To: Public Utility Commission and Staff

From: Elizabeth Graser-Lindsey
Beavercreek, OR 97004

Date: April 27, 2023

Re: PGE CEP/IRP Report filed in Docket No. [LC 80](#)

Figure 78. Decarbonization glidepath portfolios

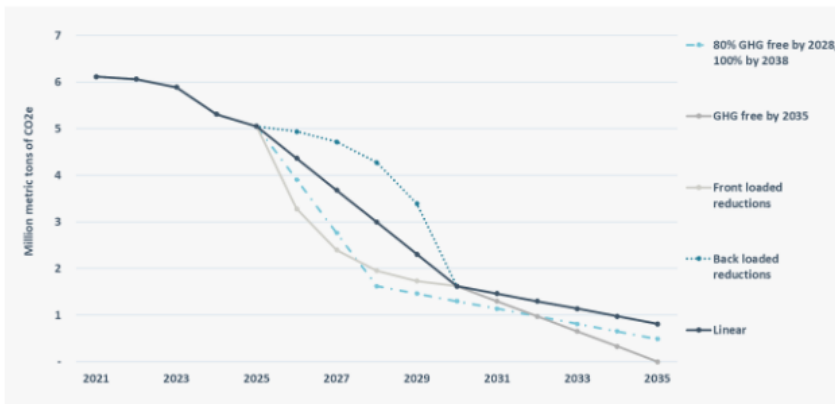
In the interest of Oregon’s low-risk and low-cost goals for electricity, PGE needs to take the front-loaded path in emission declines (the front-loaded decarbonization glide path) rather than the linear path in emissions decline (linear decarbonization glide path).

The front-loaded emission reduction is the lightest gray between 2026 and 2030. Fig. 79 p. 262.

Figure 82. Cost and risk of accelerated decarbonization glidepath portfolios

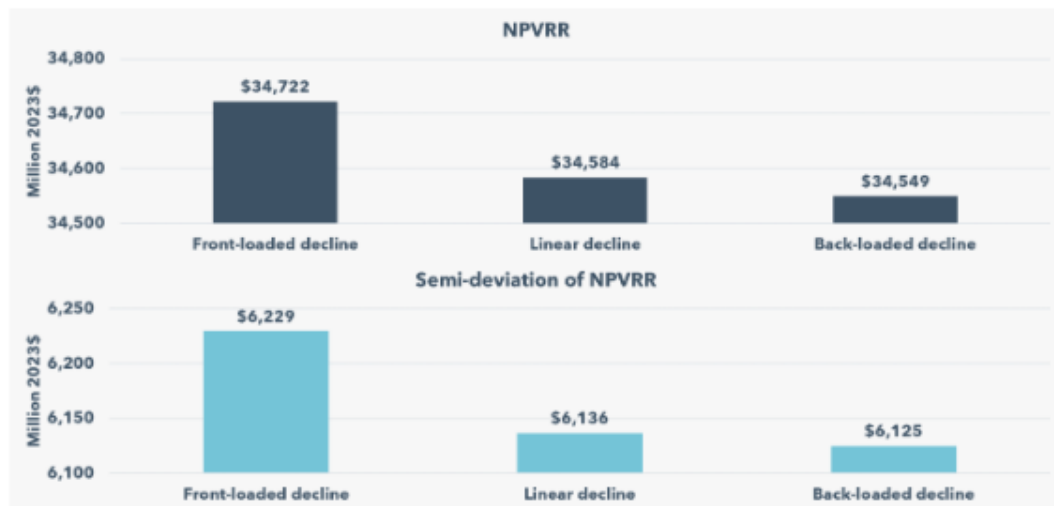
- (PGE’s NPVRR and semi-deviation of NPVRR bar graphs exaggerate the differences between the portfolios by the use of truncated bars – to show just the

tip of the bar graph – and then a stretched vertical axis on the graphs.)

The risk differential is small, so the unquantified risks, mentioned in previous bullets, are likely to exceed the unspecified, but quantified, risks. If all the risks could be quantified properly, the front-loaded option would be the more rational preferred option.
